APPEAL SUMMARY

Appeal ID: 27587	Project Address: 2020 SW 4th Ave
Hearing Date: 3/16/22	Appellant Name: A. Byron Balogh
Case No.: B-008	Appellant Phone: 503-351-1582
Appeal Type: Building	Plans Examiner/Inspector: Brian Quattlebaum, Amit Kumar
Project Type: commercial	Stories: 10 Occupancy: B, S-2 Construction Type: I-A
Building/Business Name: Jacobs Center	Fire Sprinklers: Yes - Through-out
Appeal Involves: Alteration of an existing structure, occ Change from B to A-3, other: Non-simultaneous Use	LUR or Permit Application No.: 22-112390-FA
Plan Submitted Option: pdf [File 1] [File 2]	Proposed use: Office use

**Jacobs Center -
Chegg T.I.**

CODE ANALYSIS PLAN

SHEET: **A110a**
LRS Architects, Inc. © 2022

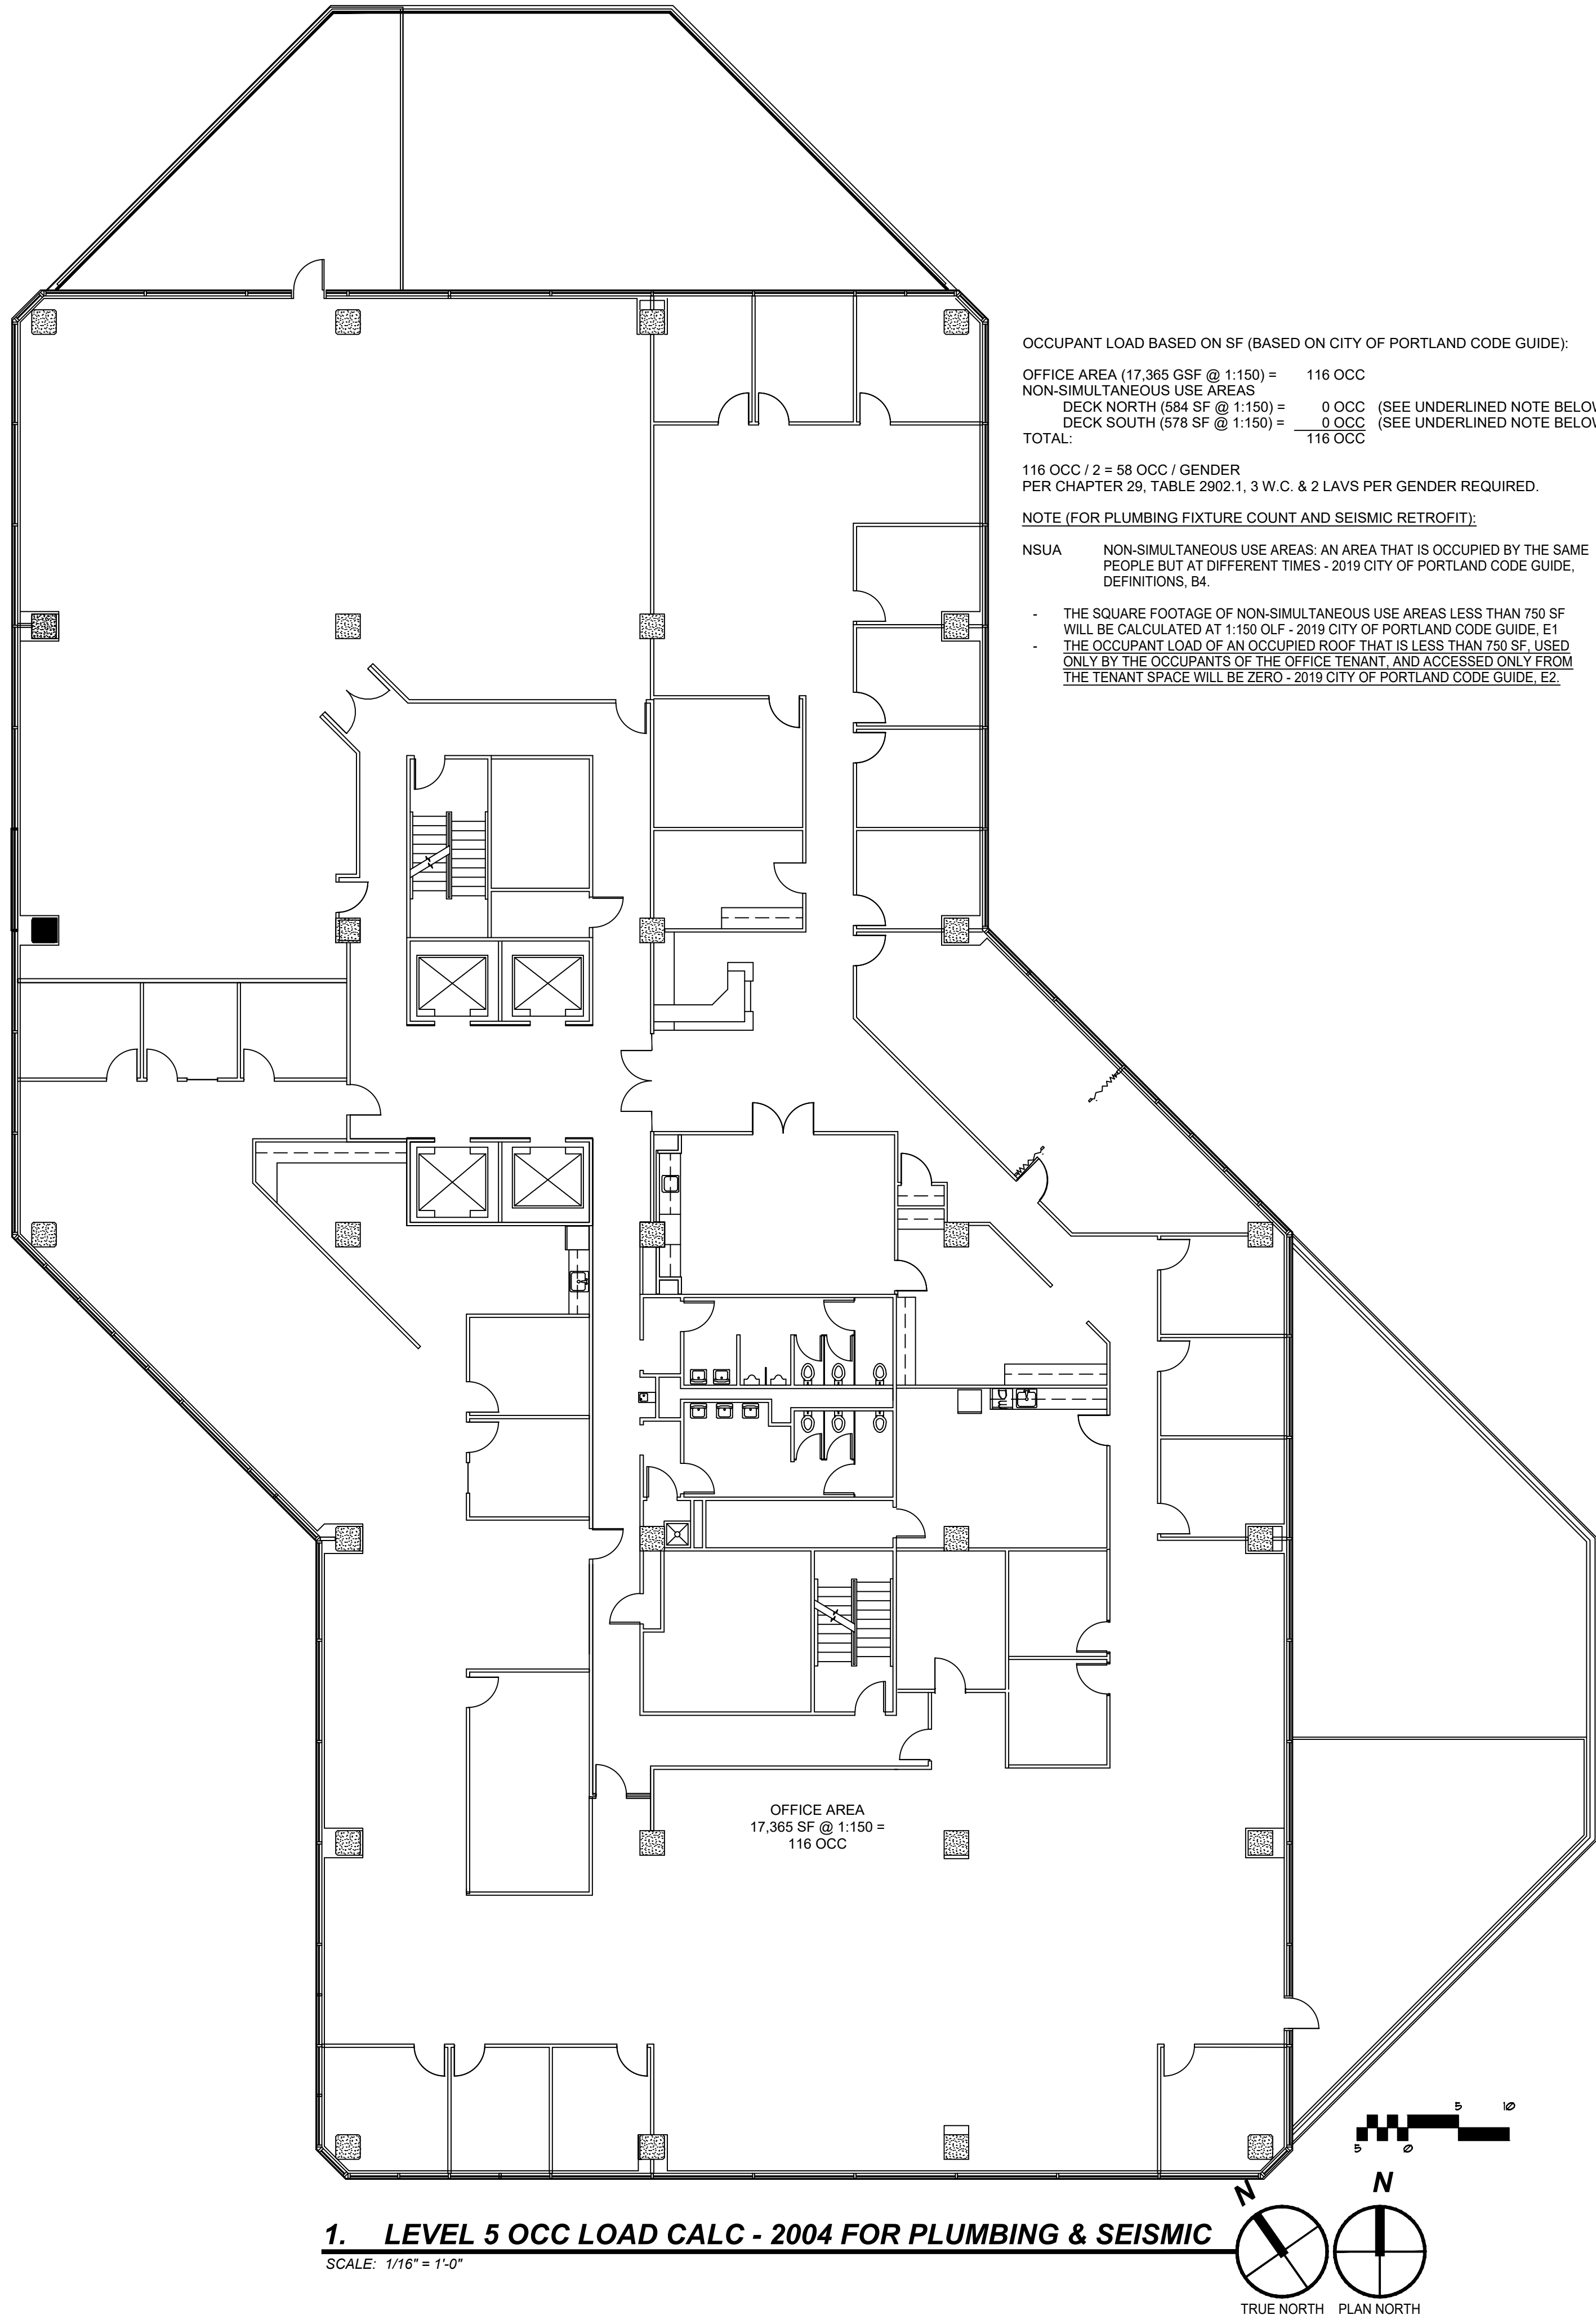
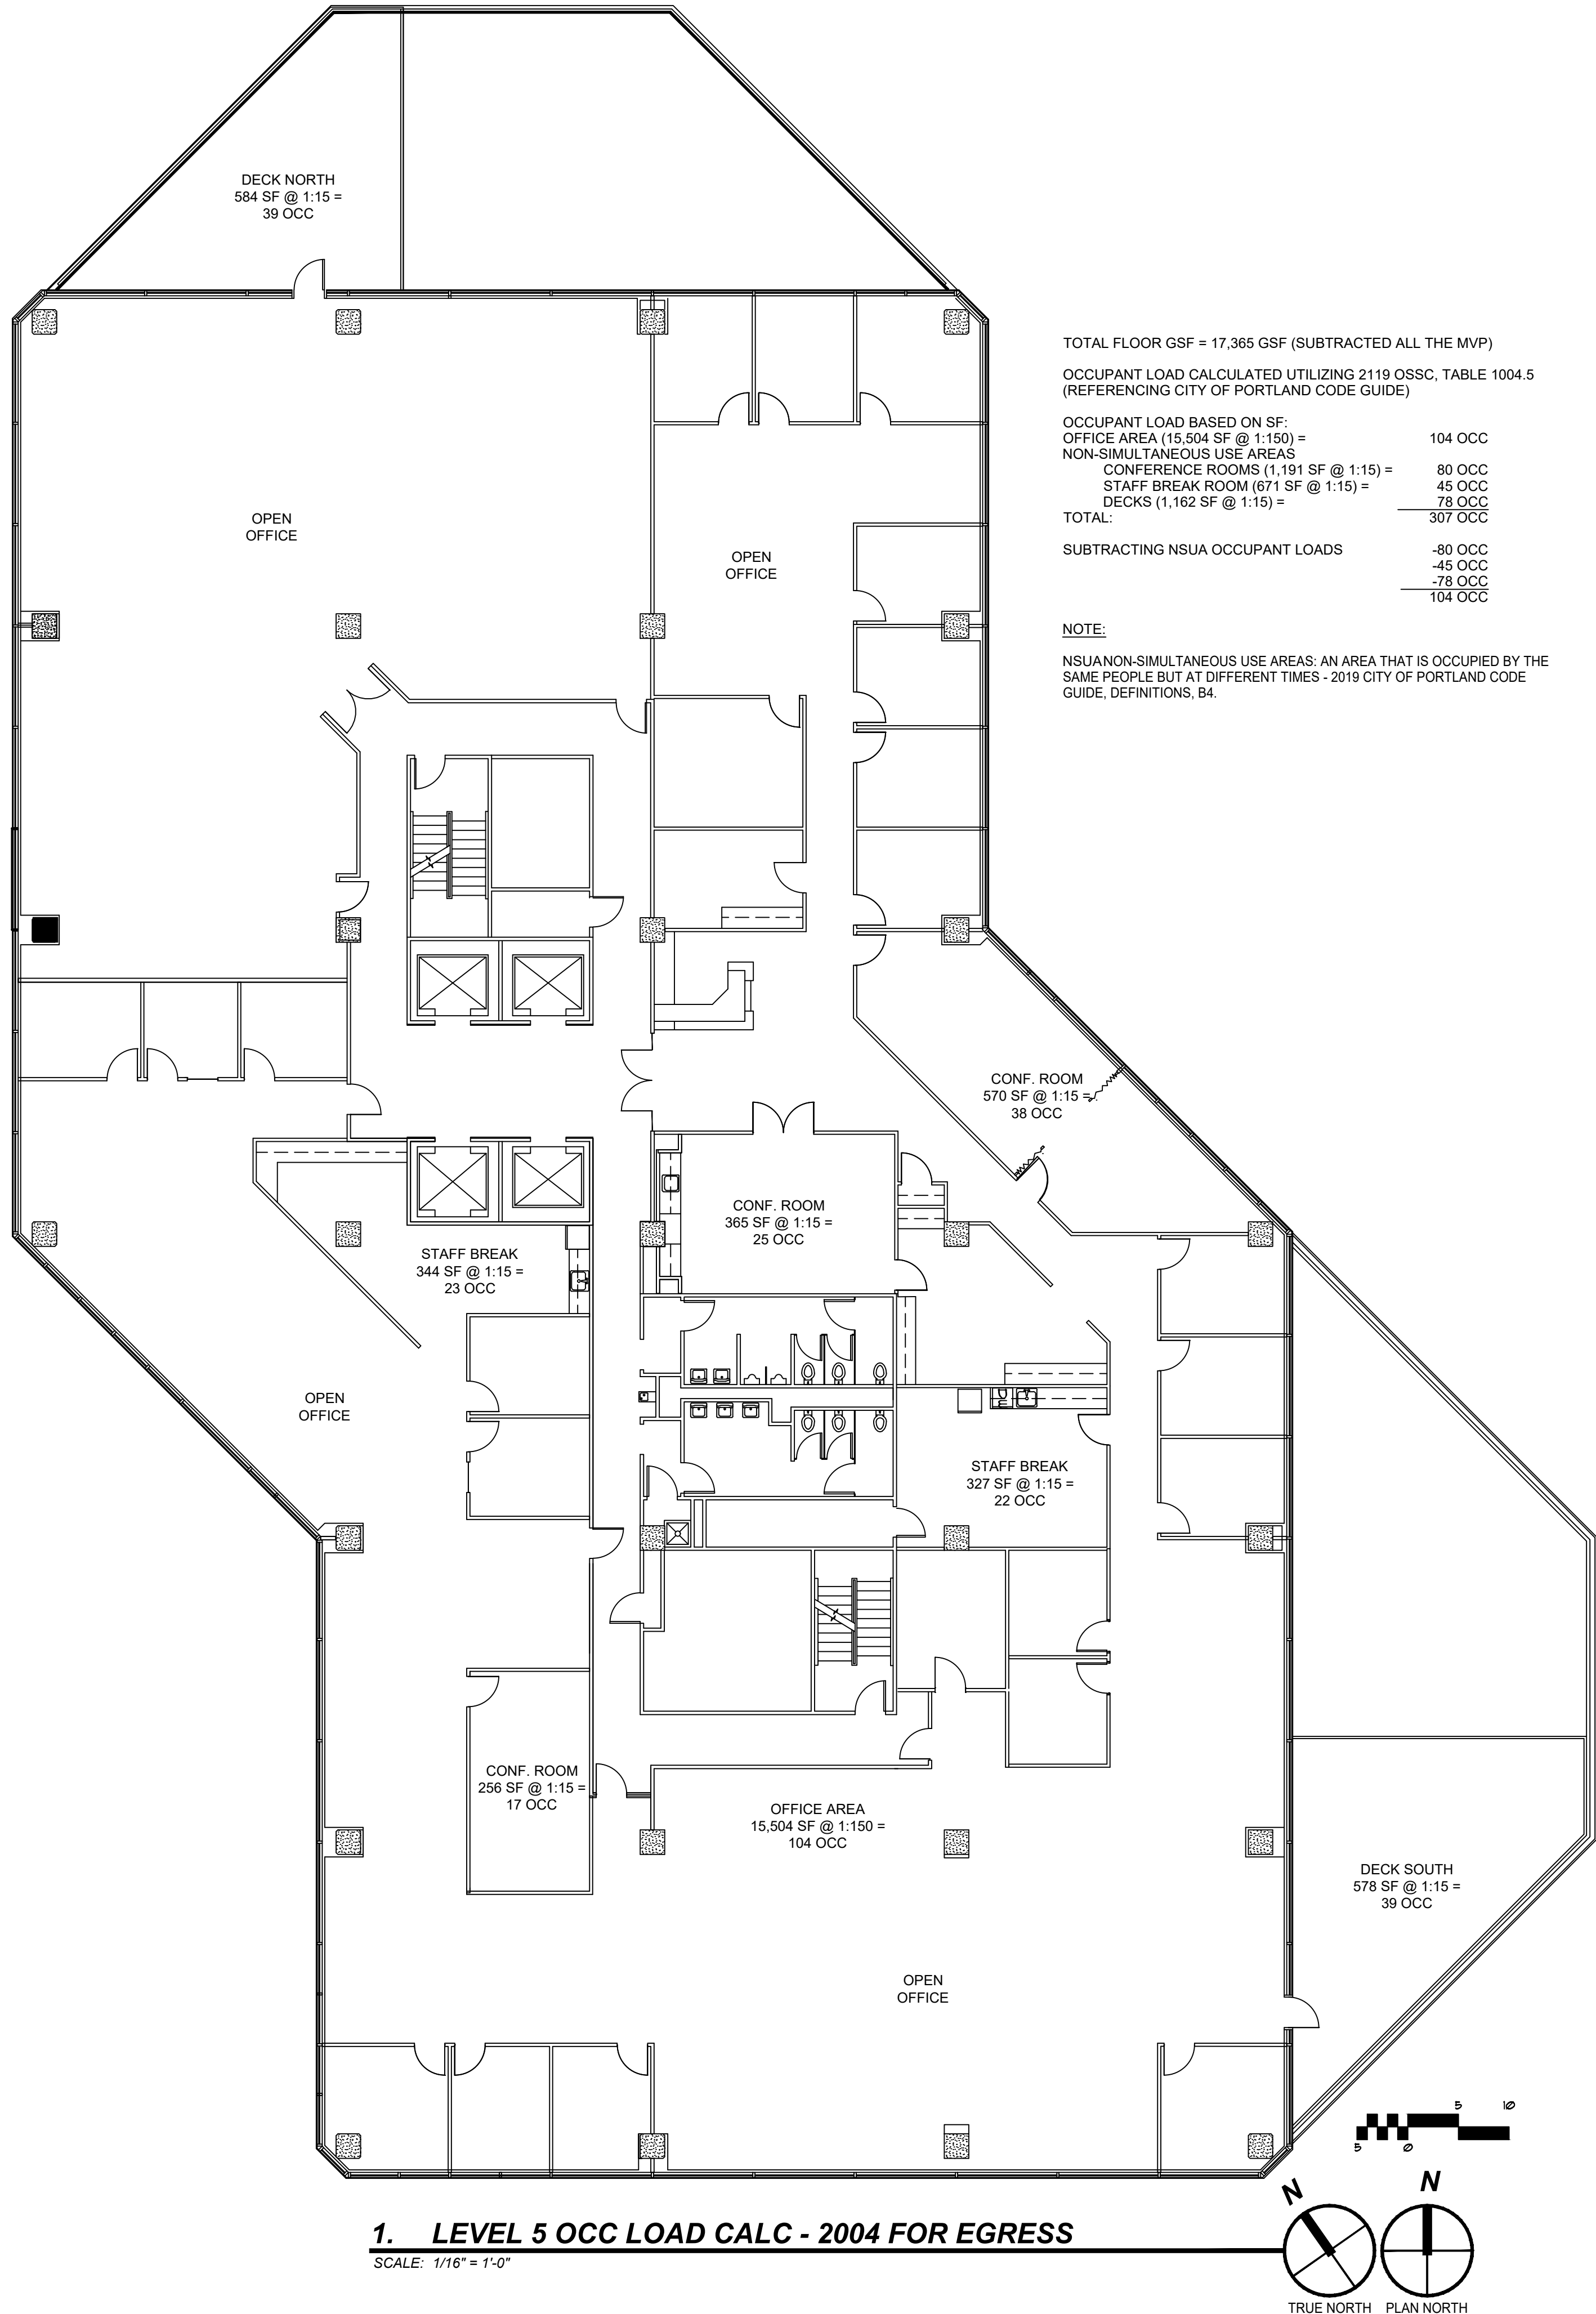
In regards to one private tenant occupying the entire 5th Floor of the Jacobs Center, this appeal item proposes that Occupant Load Calculations for Egress shall calculate all flexible workspaces, including the 1,930 sq.ft. break room, as non-simultaneous use areas according to Paragraphs D1. through D6. of the BDS Code Guide. Flexible workspaces such Conference Rooms, Huddle Rooms, Collaboration or "Collab" Rooms, employee Break Room, and two small roof deck areas, will all be non-simultaneous use areas within the 5th Floor, used strictly by Chegg staff.

In regards to one private tenant occupying the entire 5th Floor of the Jacobs Center, this appeal item proposes that Occupant Load Calculations for Seismic Retrofit Triggers shall calculate all flexible workspaces, including the 1,930 sq.ft. break room, as non-simultaneous use areas according to Paragraphs E1. through E6. of the BDS Code Guide. Flexible workspaces such Conference Rooms, Huddle Rooms, Collaboration or "Collab" Rooms, employee Break Room, and two small roof deck areas, will all be non-simultaneous use areas within the 5th Floor, used strictly by Chegg staff.

In regards to one private tenant occupying the entire 5th Floor of the Jacobs Center, this appeal item proposes that Occupant Load Calculations for Plumbing Fixtures shall calculate all flexible workspaces, including the 1,930 sq.ft. break room, as non-simultaneous use areas according to Paragraphs E1. through E6. of the BDS Code Guide. Flexible workspaces such Conference Rooms, Huddle Rooms, Collaboration or “Collab” Rooms, employee Break Room, and two small roof deck areas, will all be non-simultaneous use areas within the 5th Floor, used strictly by Chegg staff.

1. Reduction in calculated occupant load with use of draft code guide for calculation of occupant load in office spaces for purpose of egress: Denied. Proposal does not provide equivalent Life Safety protection.

2. Reduction in calculated occupant load with use of draft code guide for calculation of occupant load in office spaces for purpose of seismic retrofit triggers. Denied. Proposal does not provide equivalent Life Safety protection.

3. Reduction in calculated occupant load with use of draft code guide for calculation of occupant load in office spaces for purpose of reducing the minimum number of required plumbing fixtures: Denied. Proposal does not provide equivalent level of sanitary protection.
